## Extending Separated Bike/Pedestrian path on Grove St.

The goal of this memo is to optimize bike/pedestrian safety and encourage non-motorized use along the Grove Street corridor. There is currently a planned separated bike and pedestrian tracks in front of the Riverside Development and on the I-95 overpass. We request that serious consideration be given to extending this infrastructure to the Hamilton Recreation Center in Lower Falls and to the Williams School and ideally Auburndale Center – the Hamilton Williams Cycle Tract.

Figure 2. The proposed design in front of building 6 is illustrative. This image is modified to show an extra row of trees

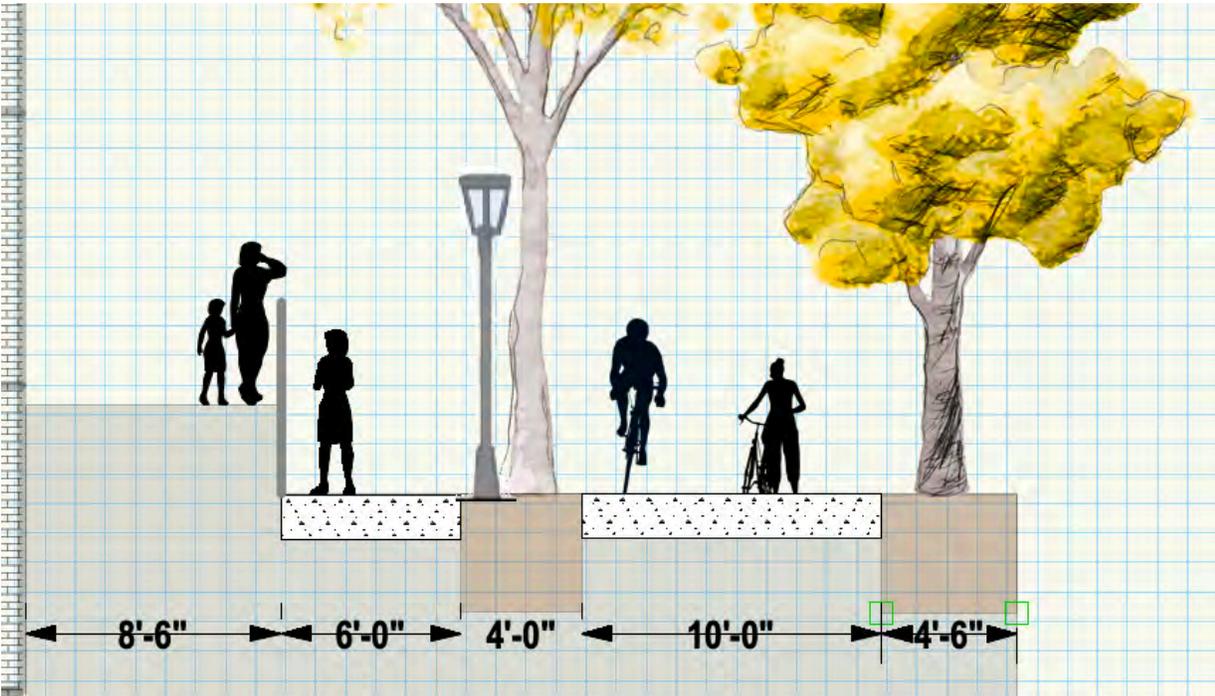
The model of a separated bike and pedestrian tracks protected from auto traffic should be maintained wherever possible.

Figure 7. Detail of Grove St. at railroad

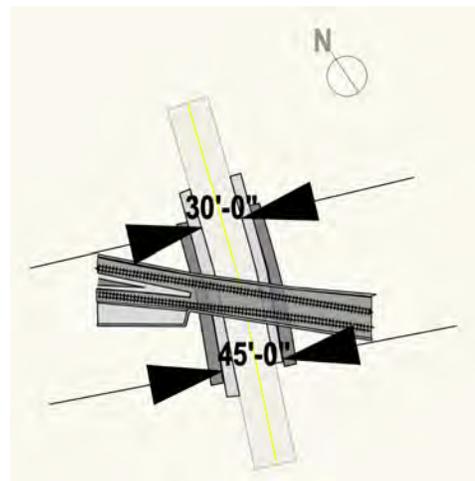
- Wall to wall distance in the railroad underpass is 45 feet, with mean sidewalk widths of eight feet on both sides and a roadway width of 30 feet.
- The existing east side sidewalk does not connect to a sidewalk in front of the golf course and therefore serves no purpose.
- A pedestrian crossing is better placed in front of the Riverside Center, where traffic is already controlled, rather than on the other side of the underpass in front of Riverside.

- The space under the overpass has sufficient width to accommodate:
  - North and south 11-foot auto lanes
  - a 10-foot wide two-way cycle track
  - a 6-foot pedestrian walk
  - 3 feet for separation barriers/curb
  - 2-foot shoulder
- The landscape plan between the Riverside Center and Grove St. already accommodates an attractive pedestrian experience. Grading and moving curb would allow a two-way cycle track to be added to this space.
- The special permit for the Riverside Center includes the following provision which should provide incentive for creating this infrastructure:

Figure 9. Grove St to Hancock St.

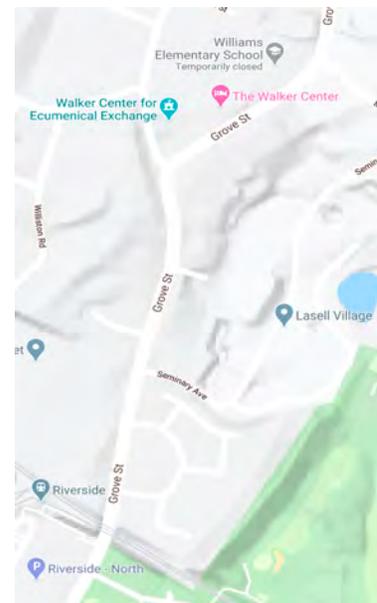
This section of Grove St beyond the north Drive of the Riverside Center to Hancock St is uphill and relatively straight, with clear sight lines and an average width of 33 feet, with a 3-foot berm and 5-foot sidewalks on both sides. Utility poles run the length of the west side berm would need to be relocated. This total width of 48 feet, with two 11-foot wide (22 feet total width) auto lanes, the balance of 26 feet should allow a reconfiguration of this section to accommodate a separated 2-way cycle track and pedestrian path (16 feet), curbs and east side sidewalk (10 feet)

Figure 10. Hancock to Auburn St.

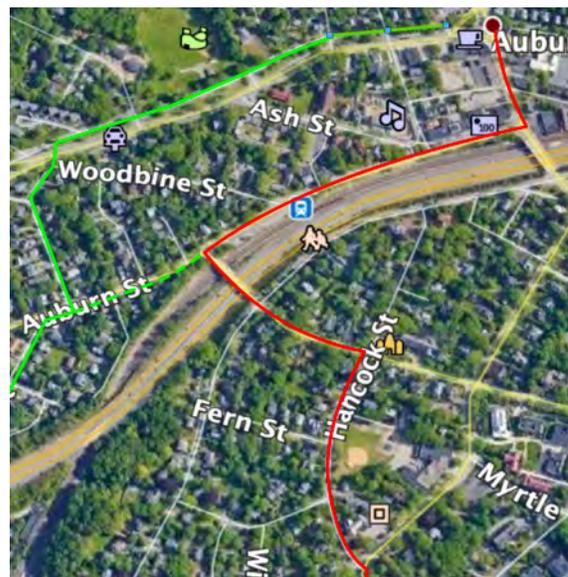
The alternative to Grove Street is to use Hancock Street, which is already one-way between Grove and Woodward during school hours. This quiet residential street could be converted to a neighborhood way providing access to the rear entrance of the Williams School, playground and ball field.

The infrastructure would be achieved by making Hancock Street in this segment one-way fulltime, using the existing sidewalk to create a grade separated pedestrian walkway. The bike lanes could be made using paint.
